ANNUAL SIDEWALK PROGRAM 2007-08
PROJECT NO. 07-010-31-006
BID NO. 07-08.001

ADDENDUM NO. 1

Date: August 10, 2007

WHEELCHAIR CURB CUT RAMP TYPE A & B

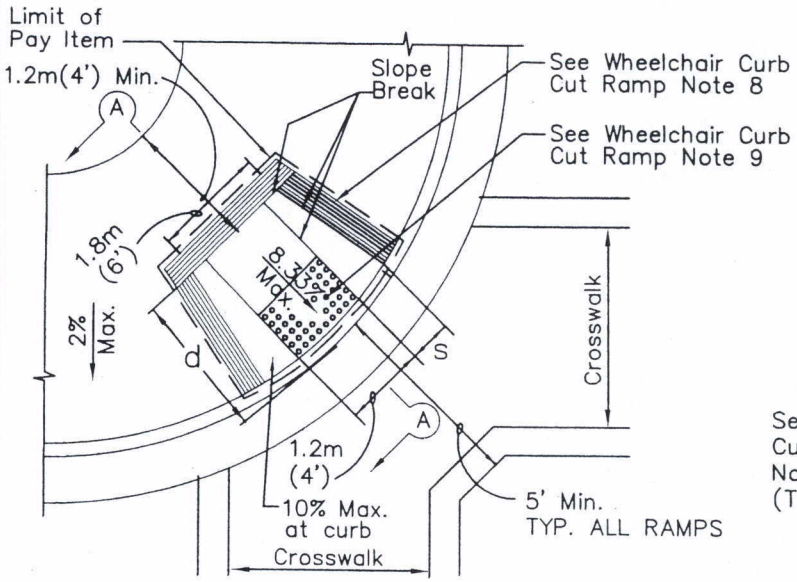
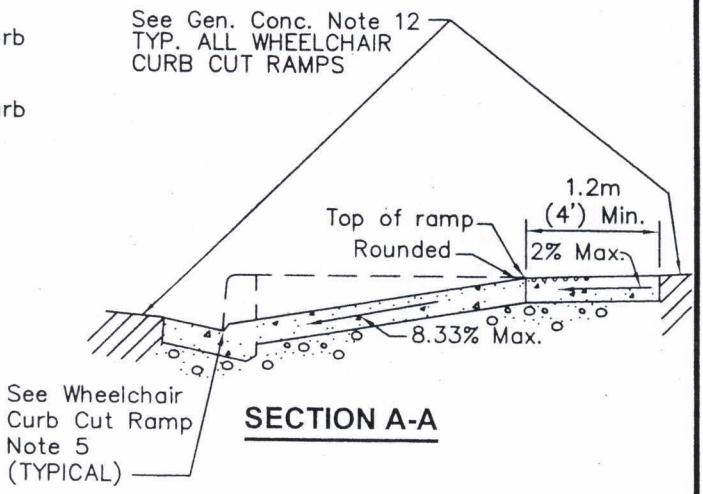
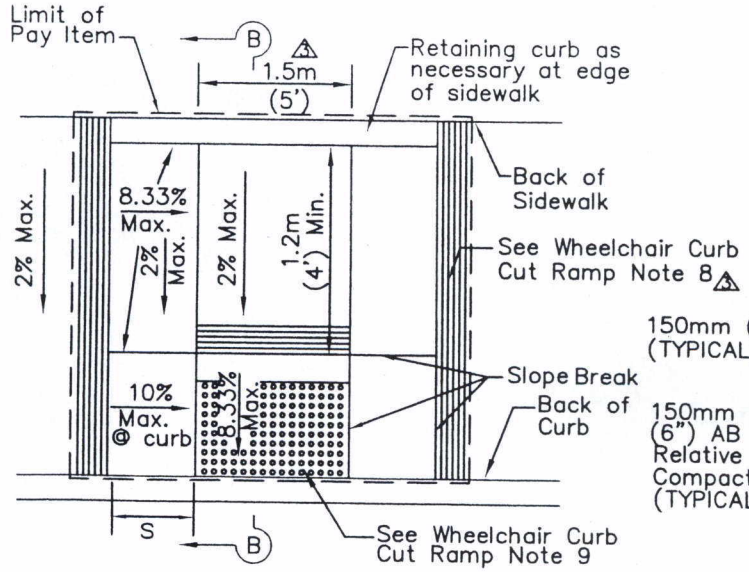
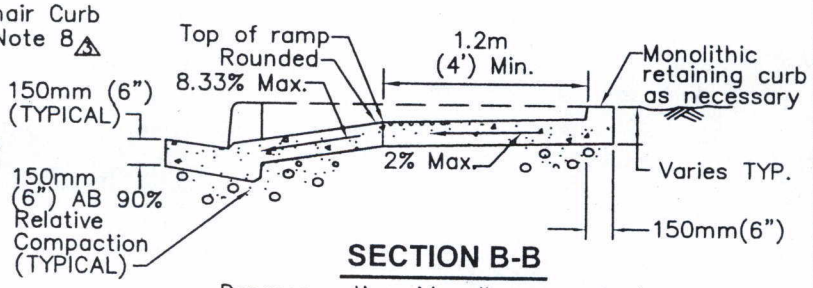
NO.	REVISIONS	DATE	BY
1	REV. DETECTABLE WARNING SURFACE	6/28/04	
2	REV. DETECTABLE WARNING SURFACE NOTES	7/1/05	
3	REV. DIM & WHEELCHAIR CURB CUT	8/9/07	AMS

WHEELCHAIR CURB CUT RAMP TYPE C & D

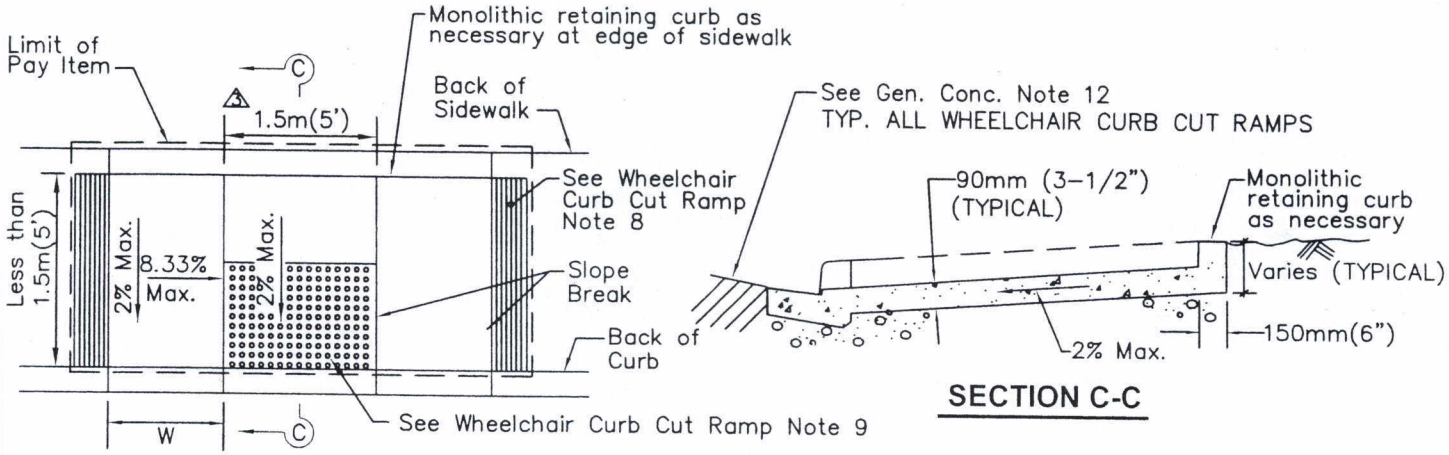
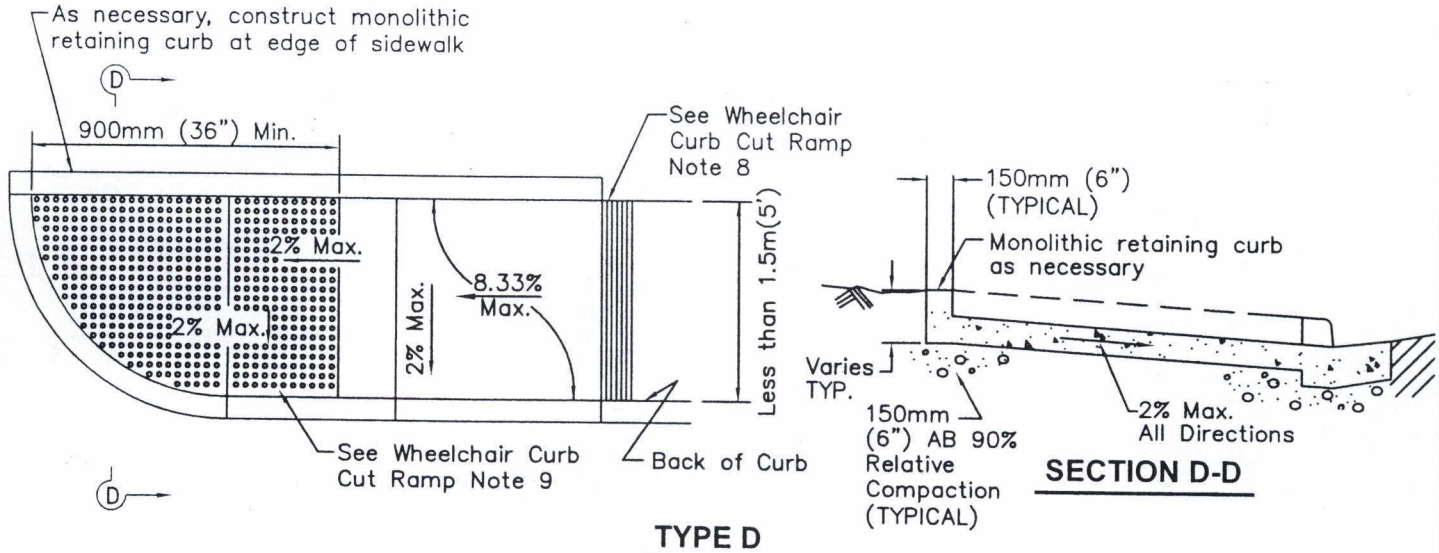
NO.	REVISIONS	DATE	BY
1	REV. DETECTABLE WARNING SURFACE	6/28/04	
2	REV. DETECTABLE WARNING SURFACE NOTES	7/1/05	
3	REV. DIM & WHEELCHAIR CURB CUT	8/9/07	AMS

WHEELCHAIR CURB CUT RAMP DETECTABLE WARNING SURFACE NOTES

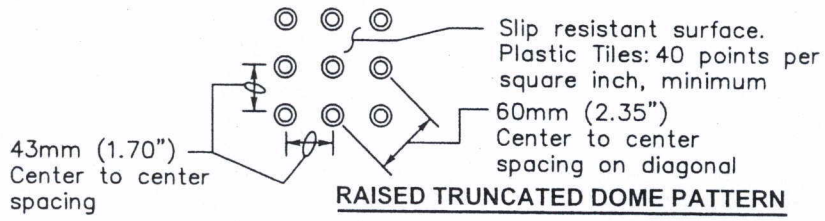
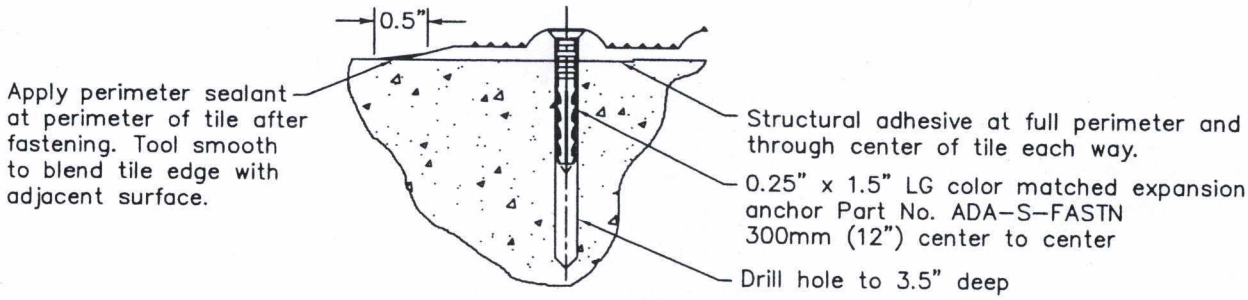
NO.	REVISIONS	DATE	BY
2	REVISED DETECTABLE WARNING SURFACE NOTES	7/1/05	
3	REV. NOTES 15 & 16	8/9/07	AMS

15. TRUNCATED DOMES – PLASTIC TILES: Tiles shall be "Armor Tile" as manufactured by Engineered Plastics Inc., Tel: (800)–682–2525, or approved equal. Tiles shall be a single tile, full width x 900mm (36") deep nominal, manufactured of an epoxy polymer composite with an ultraviolet stabilized, colorfast coating employing aluminum oxide particles in the truncated cones. Color shall be Safety Yellow (Federal Color #33538). The tile shall incorporate an in–line pattern of truncated domes; 5mm (0.20") in height, 23mm (0.90") diameter at the base, and 10mm (0.40") diameter at the top of dome, spaced 60mm (2.35") nominal as measured on a diagonal and 43mm (1.70") nominal as measured side by side; rows shall be oriented parallel with ramp direction; domes shall be aligned throughout entire detectable surface area. The field area shall consist of a nonslip surface with a minimum of 40–90 raised points .045" high, per square inch. The tile shall be maufactured with embedment flanges, 75mm (3") center to center, 25mm (1") min. depth with 16mm (5/16") diameter holes, 3 holes minimum per flange. Where tiles are cut, sealant shall be worked under the tile along perimeter wherever the embedment flange is removed.

16. TRUNCATED DOMES – CONCRETE: Upon prior approval from Engineer high strength concrete panels reinforced with pre–stressed stainless steel strands may be used. Concrete panels shall be CAST in TACT Warning Panels Tel: (530) 878–2440 or approved equal; two panels max to achieve full width x 900mm (36") deep nominal; 22mm (7/8") thick, 69 MPa (10,000 psi) high strength concrete; 1.59mm (1/16") Type 304 SS pre–stressed reinforcement strands 100mm (4") O.C. each way and along edges; color shall be yellow unless otherwise specified. Installation shall be per manufacturers directions.
